SUNDRY NOTICES AND REPORTS ON WELLS

APACHE 129 # 120

Apache Corporation proposes to P&A this well according to the attached procedure.

BLM CONDITIONS OF APPROVAL

Proposed P&A Wellbore

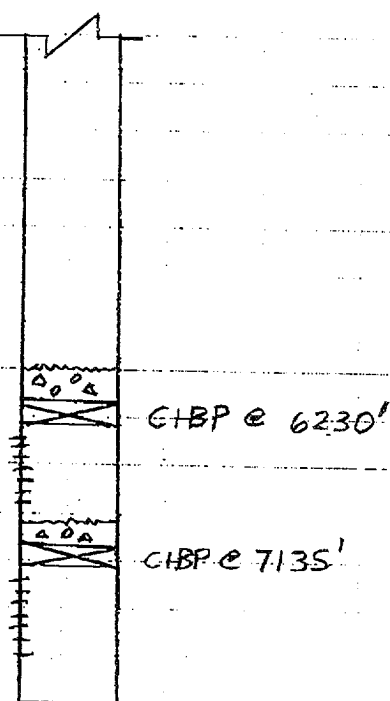
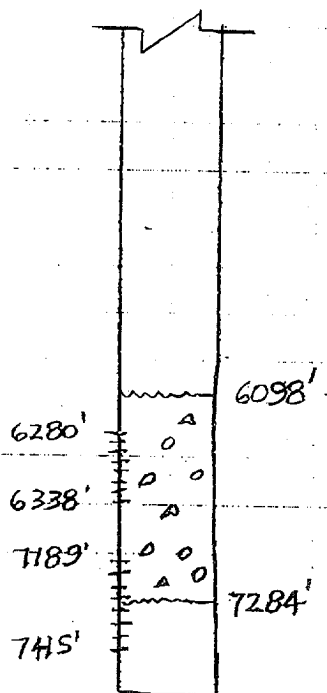
1. Plugging operations authorized are subject to the "General Requirements for Permanent Abandonment of Wells on Federal and Indian Leases."
2. For wells on Indian leases, Bryce Hammond with the Jicarilla Nation Tribal Oil and Gas Office is to be notified at least 24 hours (48 hours if possible) before the plugging operations commence. His phone number is (505) 759-1823, x-31 office, (505) 320-9741 cell. Office hours are 7:45 a.m. to 4:30 p.m.
3. Blowout prevention equipment is required.
4. The sundry is approved with the following change:
Increase surface plug to 150 sxs for 25% excess.
